**PLANNED UNIT DEVELOPMENT
& SUBDIVISION STAFF REPORT****Date: April 16, 2015****DEVELOPMENT NAME**

Springhill Landing Subdivision, Phase Two

APPLICATION NUMBER 13 DATE April 16, 2015

REQUEST Subdivision, Planned Unit Development

SITE PLAN

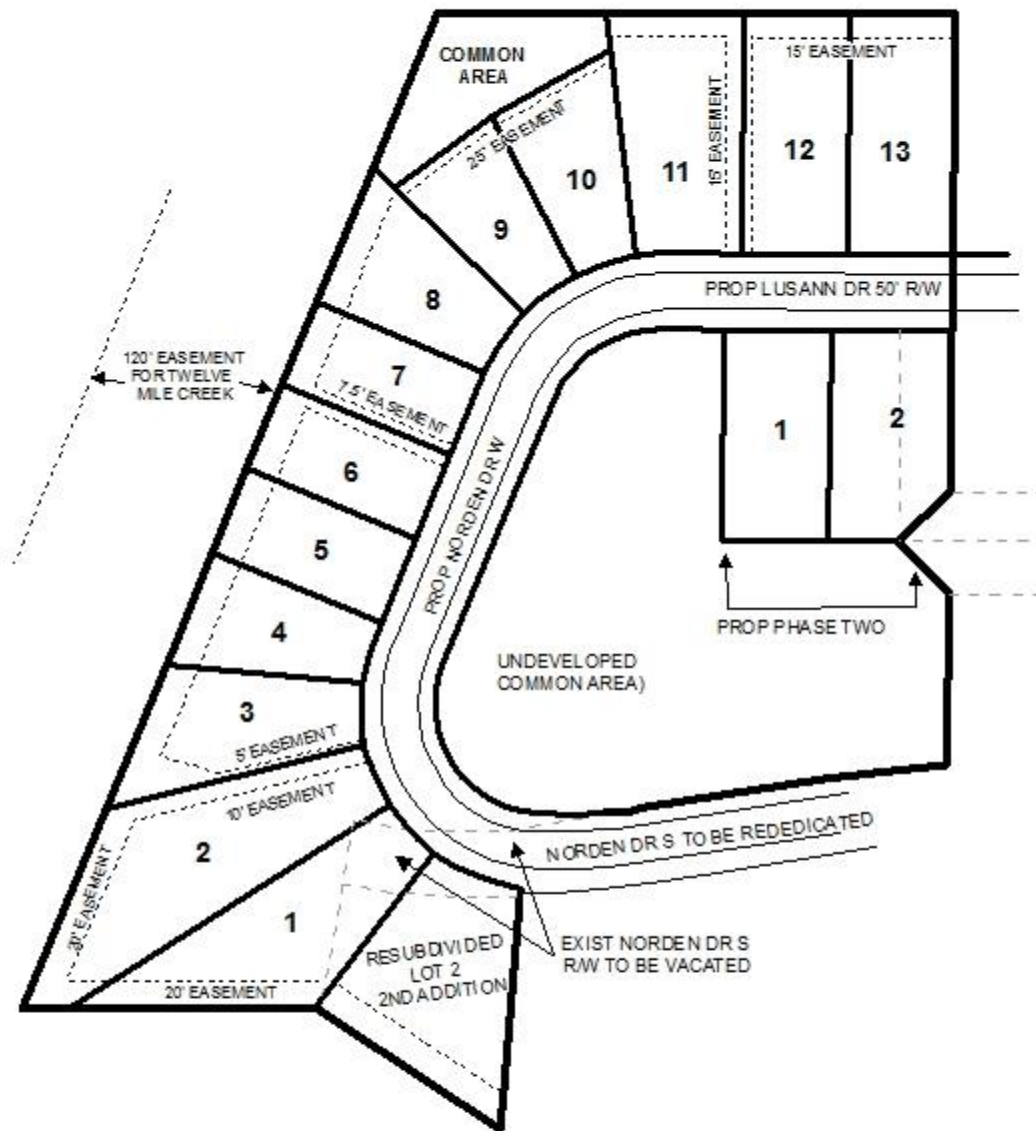
Multiple drainage, utility and sanitary sewer easements exist or are proposed for the site. A note should be placed on the PUD site plan, if approved, stating that no structure or equipment (generators, HVAC condensers, etc.) may be built within any easements. No easements are indicated in the Phase Two area.

As the PUD site abuts the floodway and drainage easement for Twelve Mile Creek, safety is of concern. A six-foot high wooden privacy fence should be placed along the rear of Lots 2-8, where they abut the floodway and drainage easement for Twelve Mile Creek. The fence should be provided as each lot is developed, subject to Engineering approval due to possible drainage issues.

- 3) revision of the plat to depict the 25-foot minimum building setback line along the Lusann Drive frontage;
- 4) revision of the plat to label each lot with its size in square feet and acres, or the furnishing of a table on the Final Plat providing the same information;

- 1) within the First Phase, depiction and labeling of the front (25 feet +), side (5feet) and rear (8 feet) setbacks for all lots, with the exception of Lot 1 which will have a side yard setback on the South boundary of 8 feet, and Lot 13, which will have a side yard setback on the East boundary of 8 feet, and for Lots 2, 6, 7 and 11, where the side yard setback on one side shall match the width of the proposed drainage and utility easements, where the easements are greater than 5 feet;

- 2) within Phase Two, depiction of the 25' minimum building setback line along the Lusann Drive frontage;
- 3) within Phase One; labeling of the maximum site coverage allowed for all lots, with Lots 1-3 and 11-13 to be 35%, and Lots 4-10 to be 40%;

- 6) revision of the site plan to depict and label the provision of a six-foot high wooden privacy fence placed along the rear of Lots 2-8, where they abut the floodway and drainage easement for Twelve Mile Creek, to be constructed as each lot is developed, subject to Engineering approval due to possible drainage issues;
